**Supplemental Filing to
Jackson Square Master Plan**
Submitted Pursuant to Article 80 of the Boston Zoning Code

75 AMORY AVENUE

May 16, 2013

**RE: Supplemental Filing to Jackson Square Master Plan
Phase 2 / Site III, 75 Amory Avenue
Boston, Massachusetts**

Figure 1. Initial Phase 2 Plan

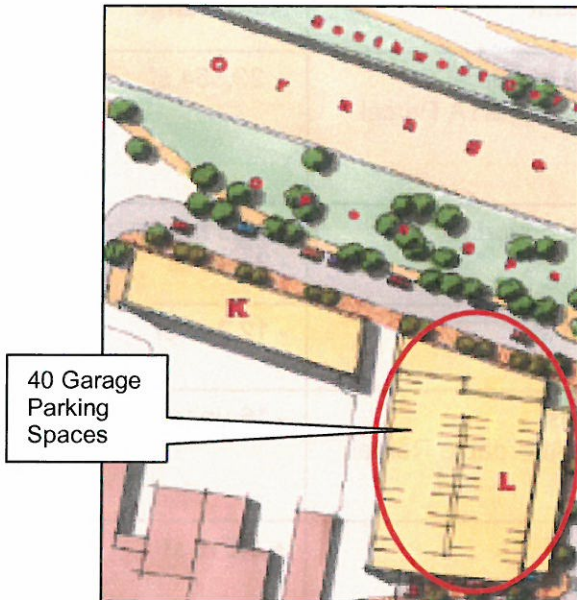
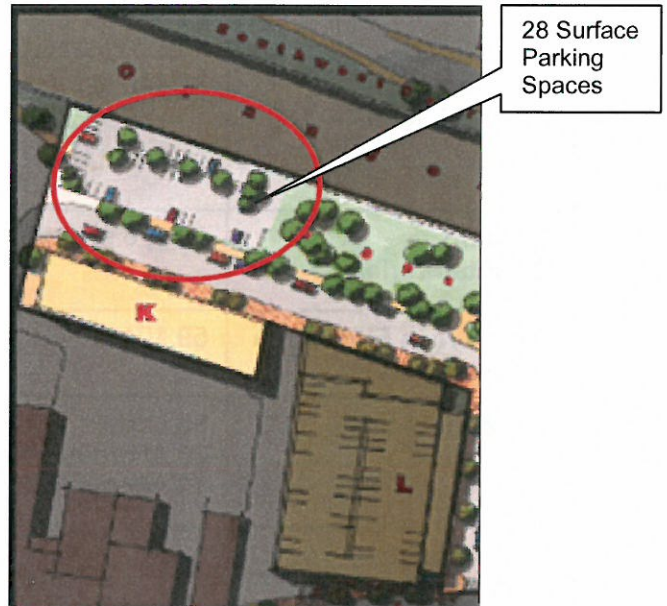
The original development program for Site III, as outlined in the DPIR, included the development of 75 Amory Avenue (Building “K”) into 55 units comprised of 19 affordable homeownership units and 36 affordable rental units. **Figure 1** below shows the initial Article 80 Phase 2 building plan.

The Phase 2, Site III project, as revised, is now proposed to consist of 39 affordable residential rental units. The ground floor will include a large common room for resident use, a property management office, recycling, bike, and laundry rooms. **Figure 2** above shows the overall Phase 2 Building Plan and proposed change in the parking program.
